FIELD SERVICE ACTION		
To: For the attention of: Please copy to:	All Dealers The Service Manager The Dealer Principal The Parts Manager Aston Martin Technician(s)	Reference: FSA:103
Model:	DB9	Issued: May 2004
VIN Range:	See attached list	
Subject:	Anti Roll Bar Drop Link Fixings	Page: 1 of 5

DB9 – Anti Roll Bar Drop Link Fixings

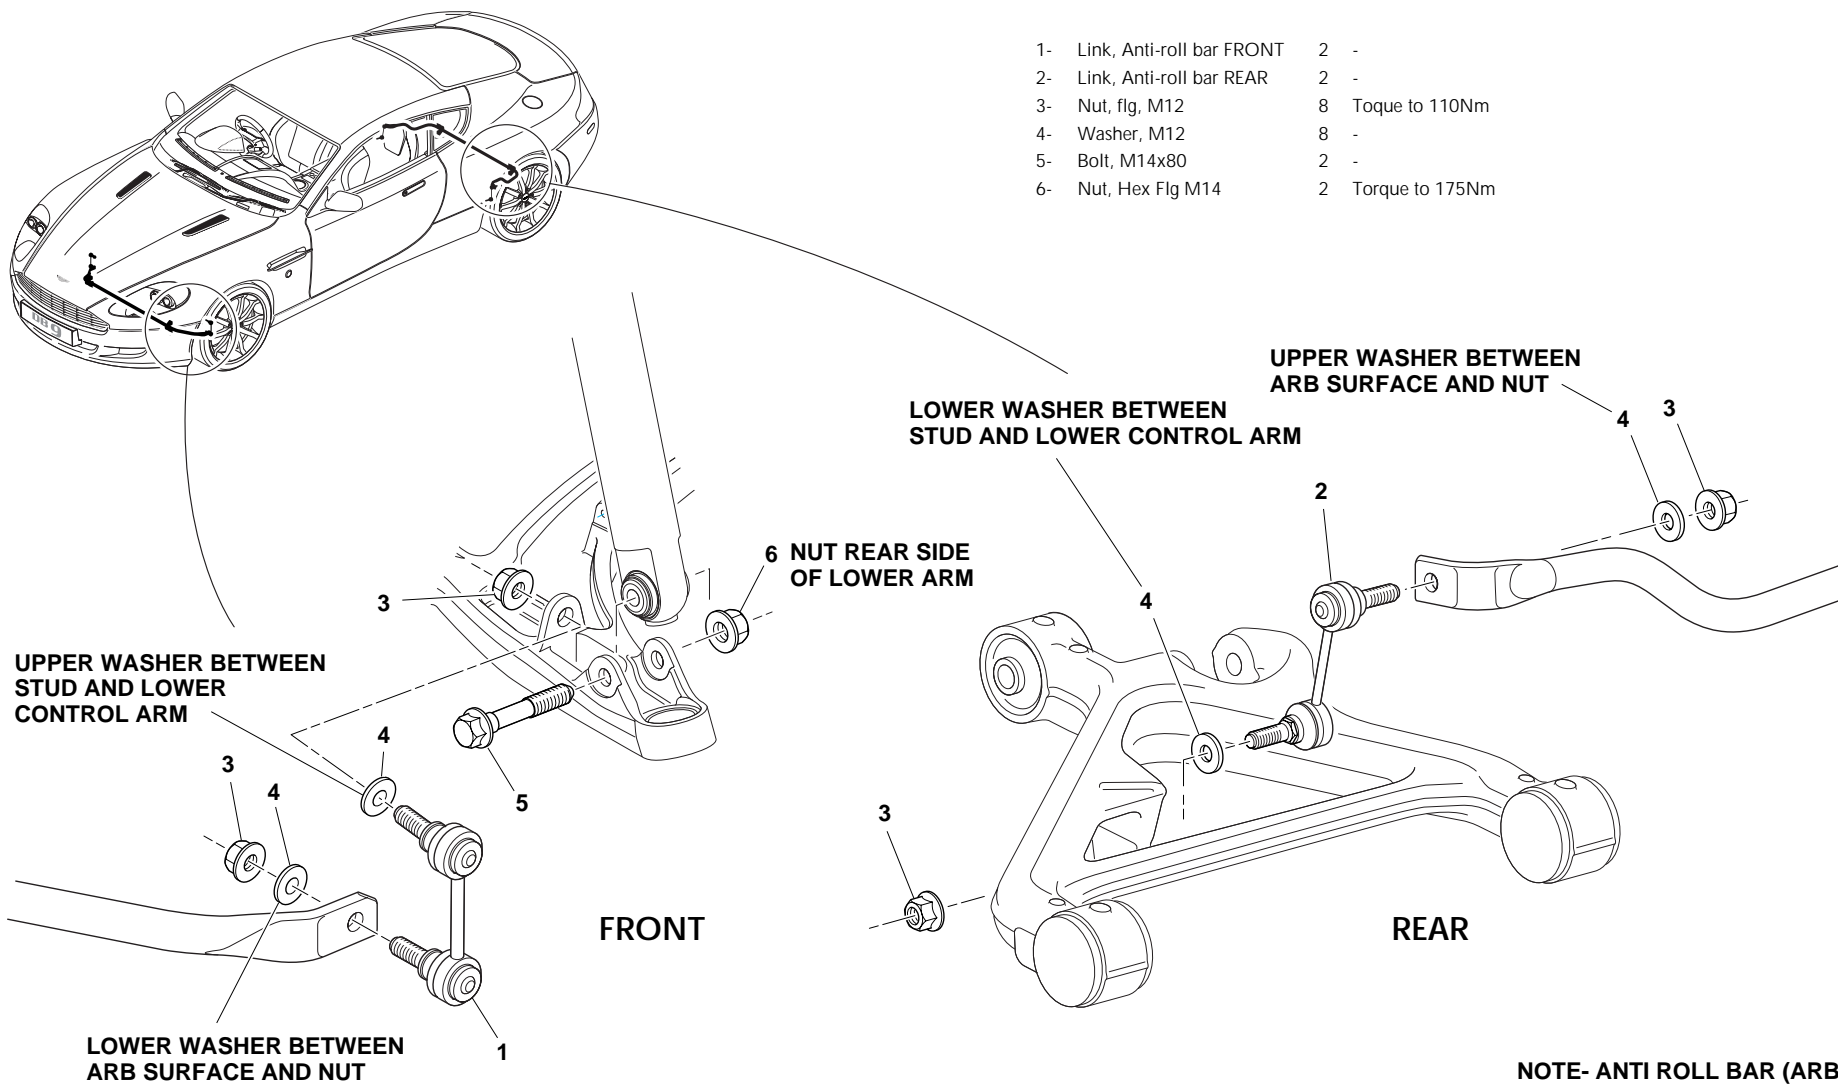
As a result of continuing Quality and Engineering investigations during the initial launch of DB9, a potential component quality issue has been identified on the Anti Roll Bar Drop Link fixings, front and rear. To address this issue, please carry out the following workshop procedure accurately as the order of assembly of the fixings is critical. See illustration for details.

- Swing the Damper outboard
- The Anti Roll Bar Link can now be removed
- Fit the new front Anti Roll Bar Link and fixings, from the Parts Kit supplied. **Note: Ensure that the order of assembly is correct in accordance with the attached illustration. At the lower fixing point the M12 Washer must be positioned between the Anti Roll Bar and the M12 Flange Nut. At the upper fixing point the M12 Washer must be positioned between the Anti Roll Bar Link and the Lower Control Arm.** Torque both M12 Flange Nuts to 110 Nm

- Fit the new rear Anti Roll Bar Link and fixings, from the Parts Kit supplied. **Note: Ensure that the order of assembly is correct in accordance with the attached illustration. At the lower fixing point the M12 Washer should be fitted between the Anti Roll Bar Link and the lower Control Arm/ Wishbone. At the upper fixing point the M12 Washer must be positioned between the Anti Roll Bar and the M12 Flange Nut.** Torque both M12 Flange Nuts to 110Nm

- Swing the Damper back into position and from the supplied Parts Kit fit the new M14 Lower Damper Bolt and Flange Nut ensuring that the nut is rearward. See illustration attached (Items 5 and 6). Downward pressure on the control arm will be required to carry out this action

FIGURE 1

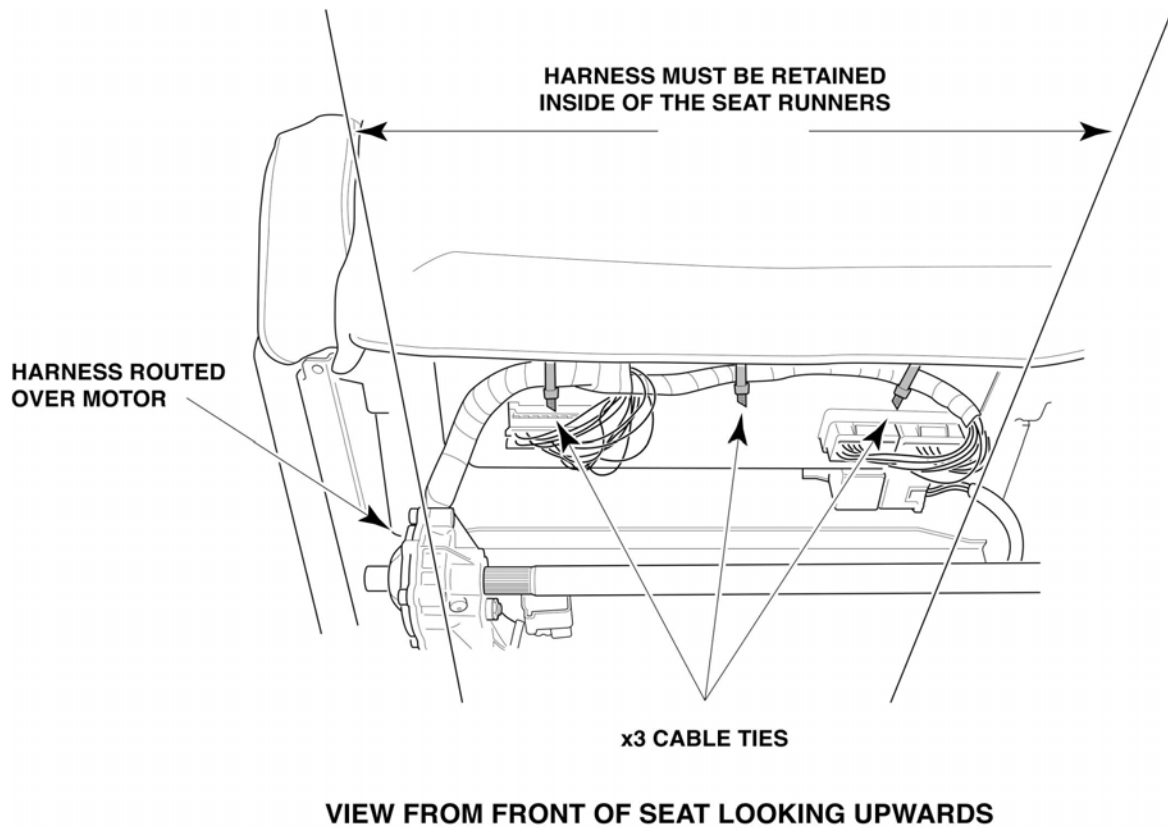
In response to feedback from the Dealer network via e-PDR, an issue has been identified where the seat wiring harness may potentially become trapped in the height adjustment mechanism whilst at full rearward travel.

- Turn the Ignition ON and power the driver's seat fully backwards and fully upwards at the front and rear
- Using a torch, inspect the seat wiring harness for correct routing, as indicated in figure 1 overleaf
- The wiring harness must route over the height adjustment motor as indicated and the three tie wraps must be tight to prevent the wiring harness from moving
- If the drivers seat is OK, please inspect the passenger seat in the same way
- If the wiring harness is not positioned as indicated in figure 1, slide the harness through the tie wraps until the required routing for the harness is obtained, as indicated in figure 1
- Tighten the tie wraps to prevent the wiring harness from moving
- Remove the vehicle protection kit

Brake boost drilling not central and close to casting edge

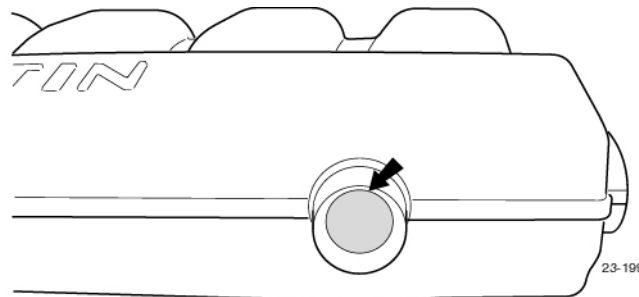
It has been identified during internal Quality investigations, that a small number of vehicles (4 cars only), may have been fitted with faulty inlet manifold assemblies. The issue is caused by a drilling error at the vacuum port for the brake booster. As shown in the illustration, the port may be off centre causing the manifold wall thickness to be below the specified 1.5mm, minimum tolerance.

PRE RE-WORK CONDITION

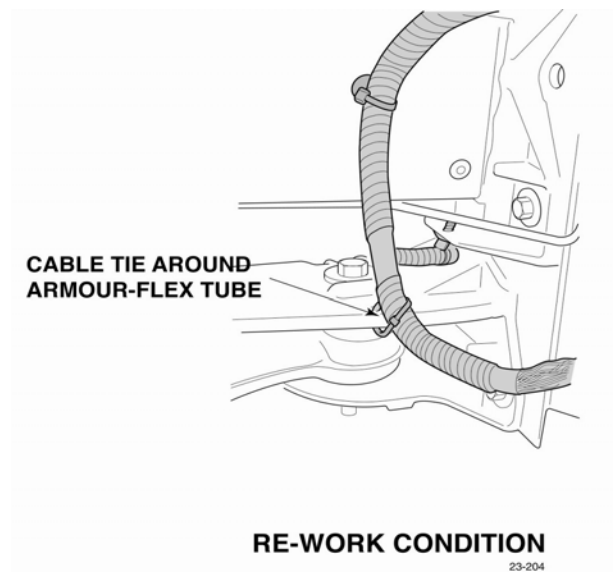
As a consequence of recent ePDR's received from the Dealer network, it has become apparent that a number of vehicles within the above VIN range, require an inspection and re-route to eliminate a potential harness chafing condition. The concern raised is a consequence of the movement and lack of security between the A.B.S harness in relation to the L/H/F subframe.

- Ensure that DB9 workshop vehicle protection kit is fitted
- Position the DB9 on a wheels free ramp and raise the vehicle
- Remove the left hand front road wheel and wheel arch liner for access
- Inspect the A.B.S harness ensuring that no visual abrasions/damage are present

- Insert a cable tie through the vertical hole in front subframe above the wishbone rear bush
- Locate the ABS harness against the lower front subframe and ensure no tension is put on the ABS module connector
- Secure the ABS harness to the subframe. Position the cable tie approx 25mm below the branch in the harness
- Insert a self fixing cable tie into the vacant hole located in the rear longitudinal beam
- Secure the upper harness within the cable tie ensuring an even distribution of the harness.
- Trim back the cable tie tails, and refit the inner wheel arch liner
- Refit the L/H/F road wheel. ENSURE THAT THE CORRECT TORQUE PROCEDURE IS USED FOR TIGHTENING THE WHEEL NUTS, I.E. 80Nm THEN 130Nm
- Remove the vehicle from the lift

FIG 1- POSITIONS OF THE SPRING BAND CLIPS

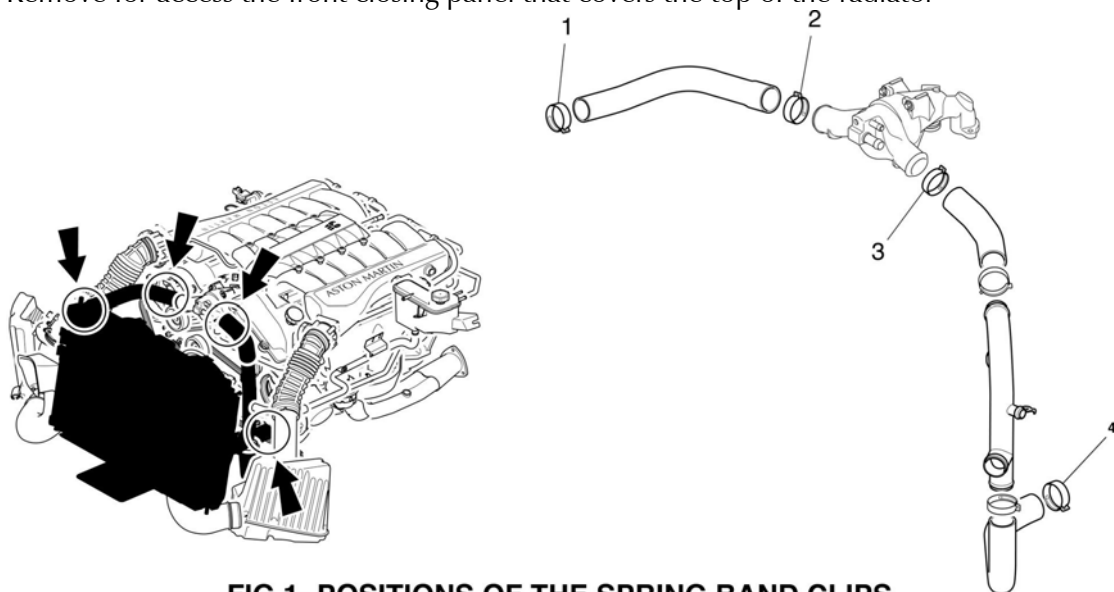
In response to feedback received from our Engineering Department, two issues have been identified with Spring Band Clamps fitted to certain cooling system hoses on DB9. Harness damage may occur due to a potential foul condition between the front harness and the top radiator hose Spring Band Clamp. Additionally, some hose connections in the cooling system may potentially become unsecured as a result of contamination at the hose to spigot interface joints. This Field Service Action is therefore being released to advise the Dealer network to replace four Spring Band Clamps with Worm Drive Clips, also to orientate the top radiator breather hose Spring Band Clamp to prevent possible harness damage occurring in service.

- Remove the Spring Band Clamps in positions 1 and 2 from the top radiator hose on the left hand side of the vehicle, as viewed from the front. (See figure 1)

FIG 2- TOP RADIATOR HOSE

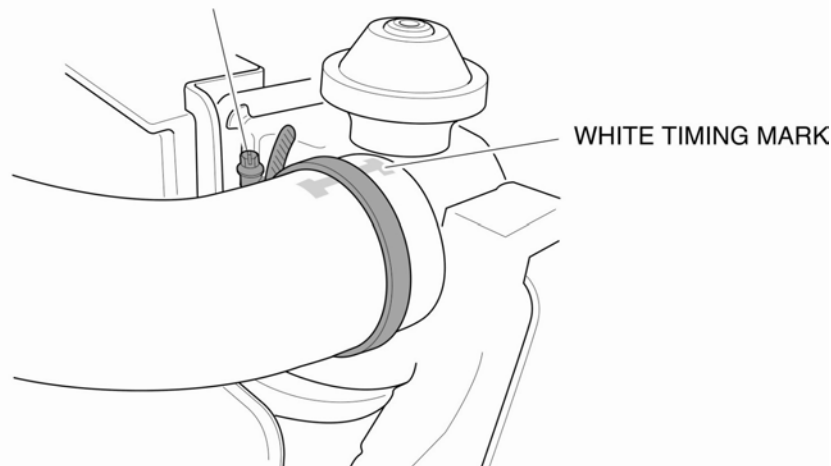
- Clean the internal ends of the top hose using the same cleaning/ degreasing agent and a clean cloth to remove any trace of contamination
- Refit the top hose into the correct position and secure it with 2 x Worm Band Clamps as direct replacements for the original Spring Band Clamps. **Note: Each clamp should be fitted central to the white timing mark on each end of the hose. The clamp at position 1 (Top radiator spigot) should have the worm drive positioned inboard (See figure 2). The clamp at position 2 (Thermostat spigot) should have the worm drive in the forward position (See figure 3)**

MAKE SURE THE WORM DRIVE
CLIP IS POSITIONED INBOARD,
CENTRAL TO WHITE TIMING MARK

FIG 4- WATERPUMP SPIGOT

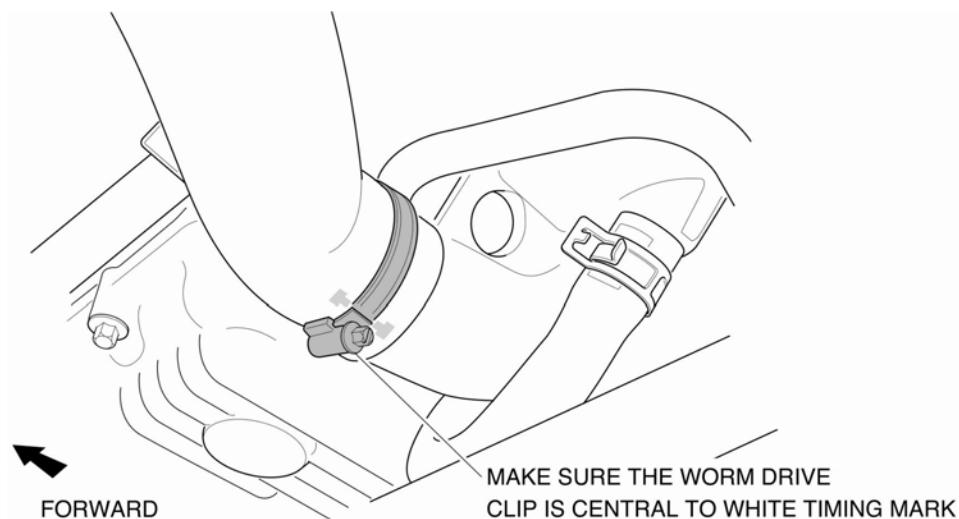
- Torque both clips to 3Nm
- Next remove Spring Band Clamp in position 3 on the hose fitted to the opposing side of the thermostat housing. See figure 1
- Again clean the thermostat spigot and the internal end of the hose using the previously recommended cleaning/degreasing agents
- Refit the hose into position and secure with another Worm Band Clamp as a replacement for the original Spring Band Clamp. **Note: Again ensure that the clamp is fitted central to the white timing mark on the end of the hose. This clamp should also be fitted with the worm drive in the forward position (See figure 3)**
- Torque to 3 Nm
- Remove Spring Band Clamp in position 4, fitted to the water pump spigot. (See figure 1)
- Remove the hose from the spigot and clean both areas as directed previously
- Refit the hose with a Worm Band Clamp has a direct replacement for the original Spring Band Clamp

- **Note: Ensure that the clamp is centrally located within the white timing mark on the hose and that the worm drive is positioned downward. (See figure 4)**
- Torque to 3 Nm
- Locate the top radiator breather hose Spring Band Clamp on the right hand side of the vehicle viewed from the front (See figure 5)
- Using pliers, open the Spring Band Clip and rotate 90° outwards towards front fender, making sure that there is no rotation of the coolant hose during this procedure (See figure 5)

FIG 6- VIEW LOOKING DOWN ONTO RADIATOR LOCATING GROMMET

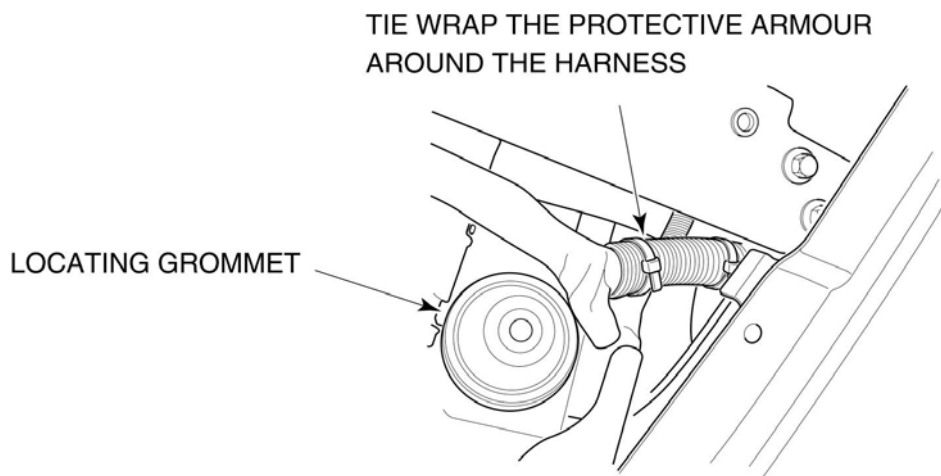
- Fit the harness armour (supplied) over the harness and secure it with the two tie wraps. Trim off any excess (See figure 6)

Figure 1

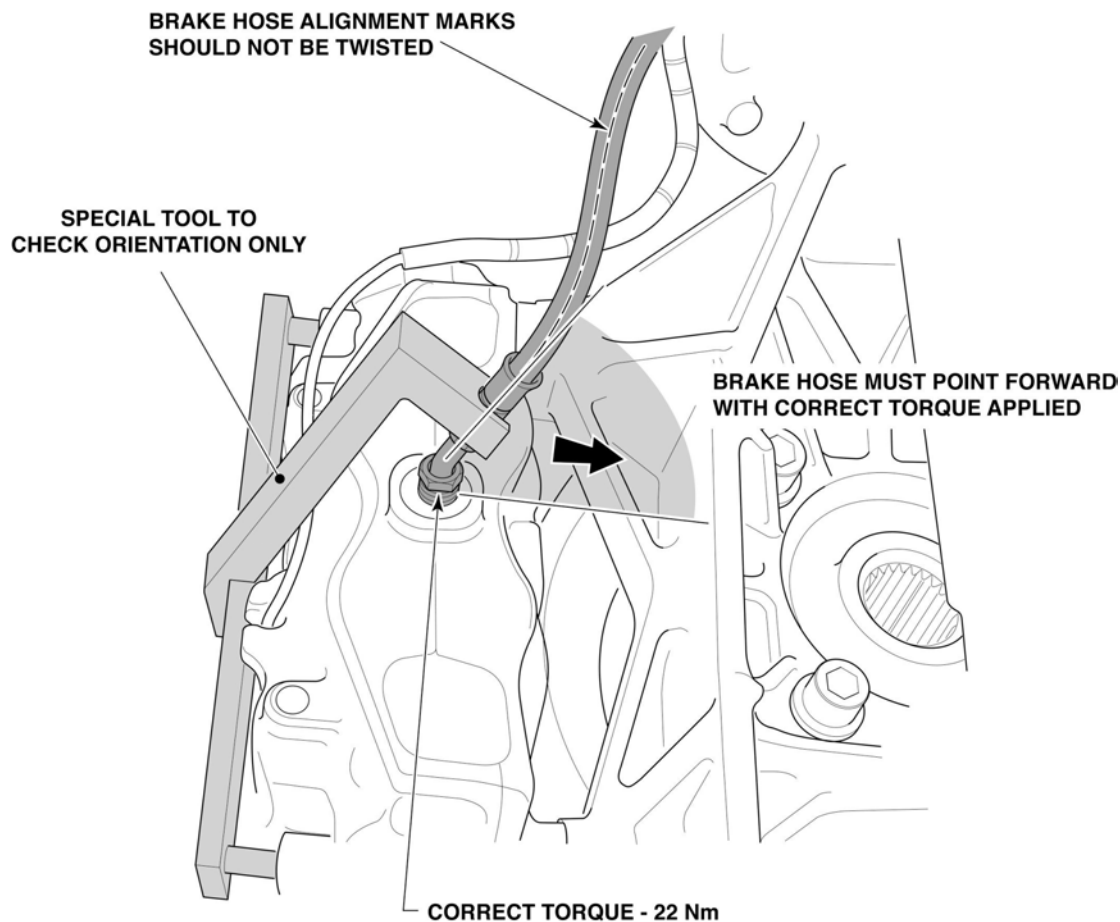
- Place the vehicle on a vehicle lift and remove all the road wheels
- The following operation needs to be carried out on both front brake calipers
- Using a 7/16 crowsfoot and a 0 to 50 Nm torque wrench check the front brake flexible pipe union to brake caliper is torqued to 22 Nm
- Referring to figure 1 overleaf, use the Brake Pipe Alignment Tool Part Number 206-100 to check for the correct brake pipe alignment, also check that the alignment marks on the flexible hose are in a straight line

Note:- figure 1 shows Left hand front caliper only, the brake pipe will still route towards the front of the car on the right hand side

- If the torque is correct, the pipe did not move during checking and the alignment is correct, no further action is required
- If the pipe is seen to move due to the torque being incorrect, or if the pipe orientation is incorrect, proceed as follows:
- Carefully back off the flexible hose union at the brake caliper until the pipe can be rotated backwards to allow forward movement when being re-torqued
- Re-torque the brake pipe union to 22Nm, then recheck all alignments as listed above
- If the correct alignment is not achieved readjust until the correct alignment is achieved
- Refit the front road wheels and initially torque to first 80 Nm then again to 135 Nm using a cross torque pattern

FIG A- LOWER DOOR CASING DUAL LOCK PAD LOCATIONS

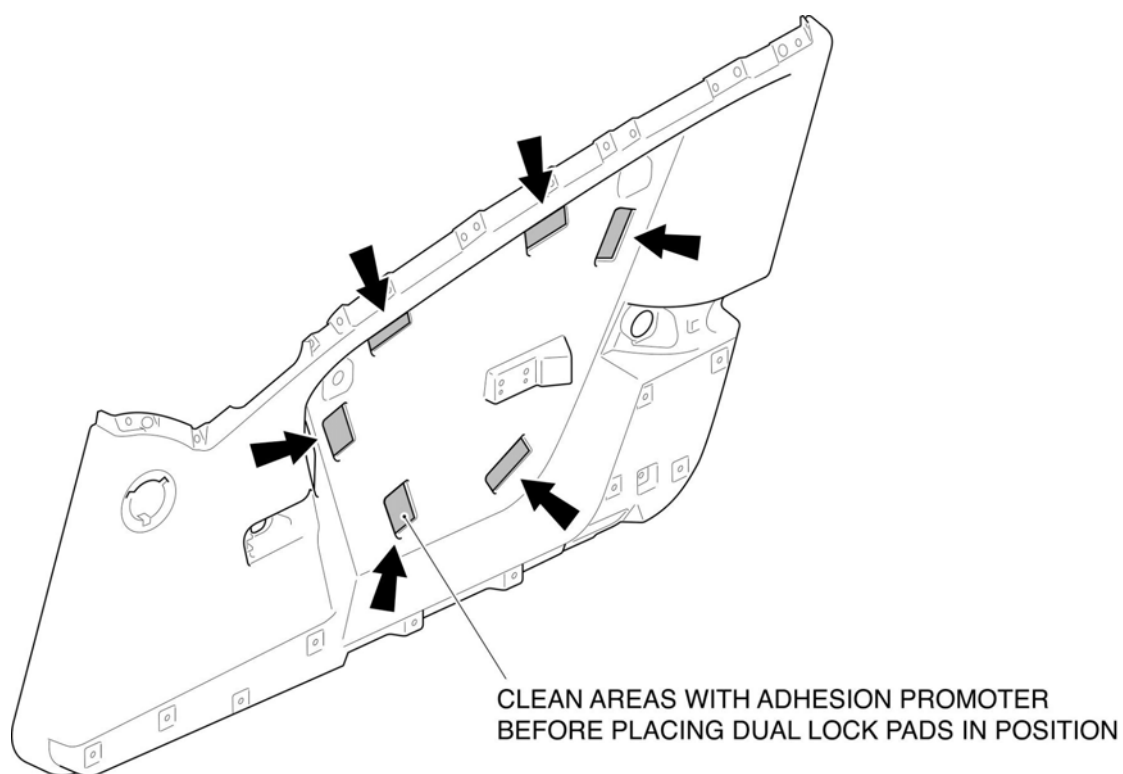
In response to feedback from our Engineering Department, it has been identified that the door infill panel may become detached from the door casing due to high ambient temperature and a reaction with the bonding material.

- Remove the door pull
- Remove the Infill panel from the lower door casing
- Remove any existing tape from both the door casing and Infill panel
- Using 3M Surface Cleaner (Part Number 3M VHB), carefully clean the six locations shown by the arrows in **Fig A**. Ensure none of the previous glue is present
- Using 3M Surface Cleaner (Part Number 3M VHB), carefully clean the darker shaded area shown in **Fig B**. Ensure none of the previous glue is present
- Place the Velcro pads on the door casing in the positions shown by the arrows in **Fig A**
- Place the Velcro pads to the Infill panel so they align with the Velcro pads in the door casing. See **Fig B**
- Align the Infill panel to the door casing and re-fit
- Refit the Door pull
- Repeat procedure for other door
